DRAINAGE NARRATIVE

ENGINEER'S SEAL  6/6/16 DAVID SOULE P.E. #14522	2900 A&B CORONA DRIVE GRADING AND DRAINAGE PLAN	DRAWN BY WCVJ DATE 6-05-16 21625-LAYOUT-6-05-16
	 1606 CENTRAL AVENUE SE SUITE 201 ALBUQUERQUE, NM 87106 (505) 872-0899	SHEET # JOB # 21625

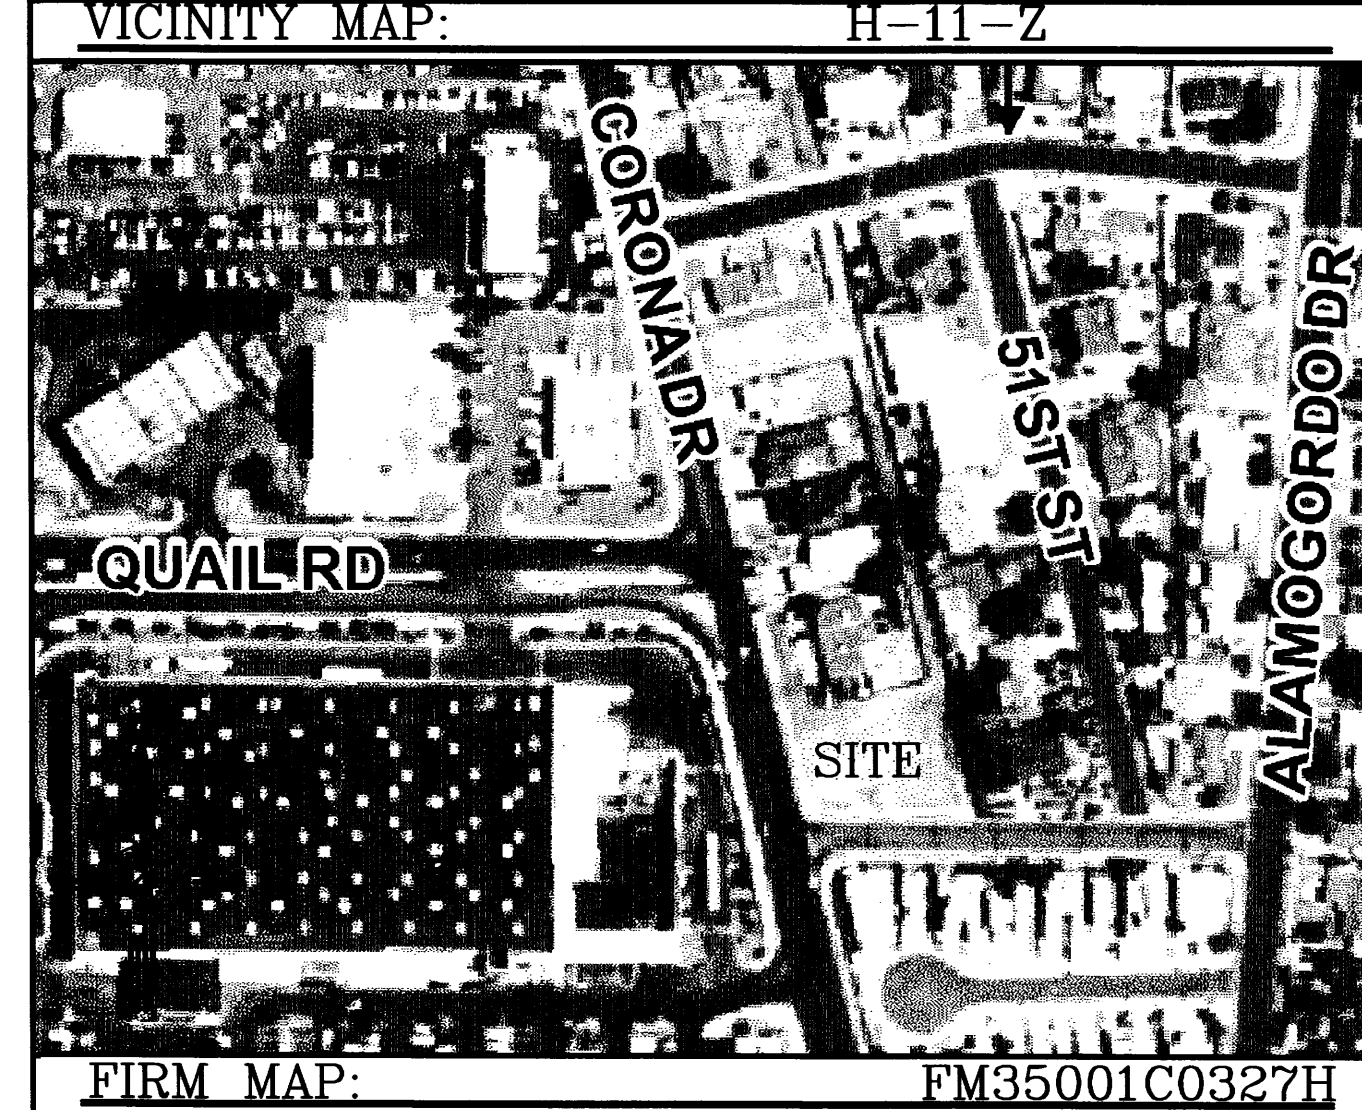
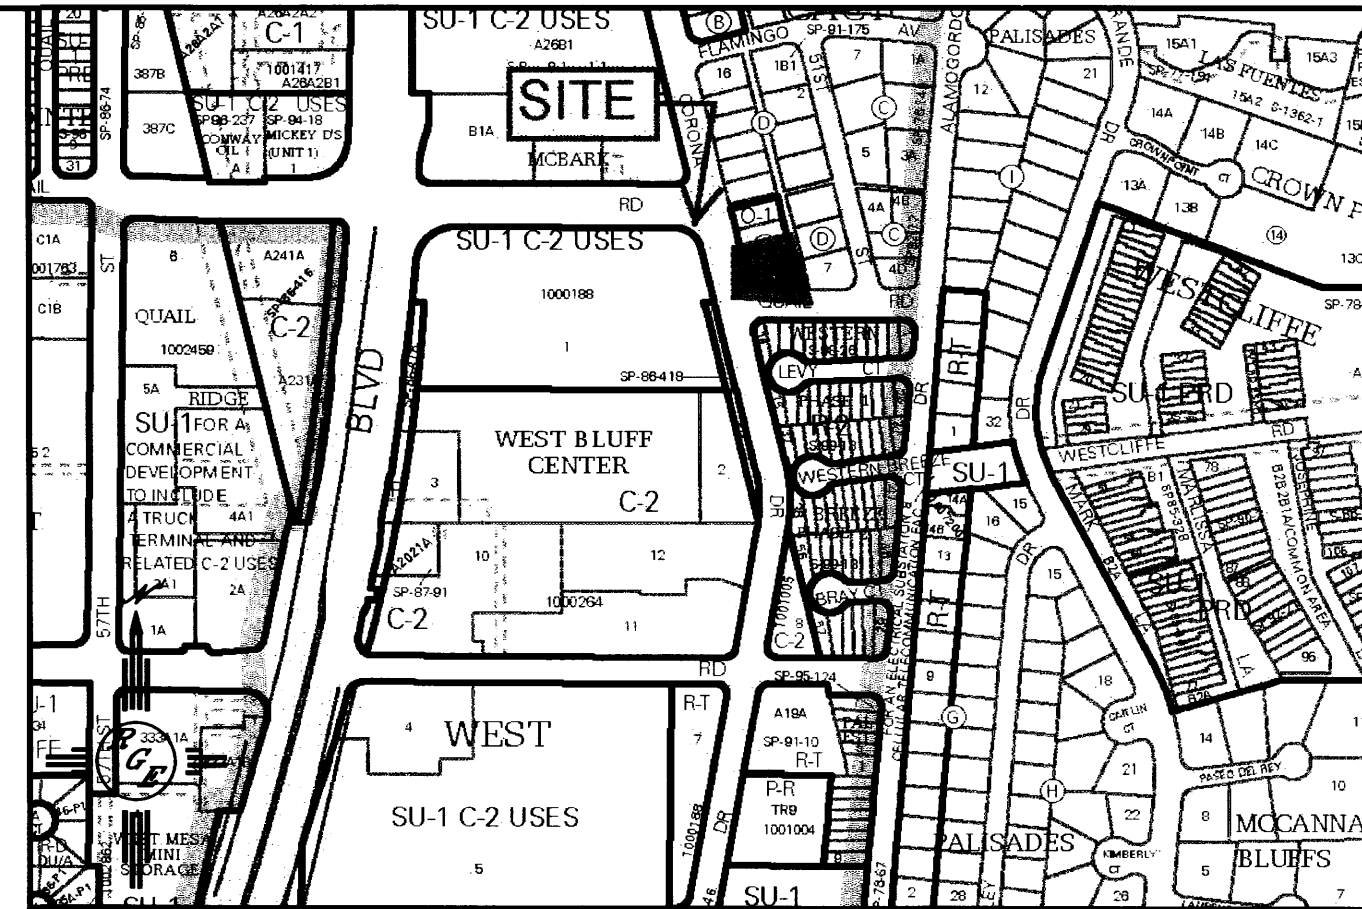
Mention that the roof drains are expected to send flows N, E or S not W.
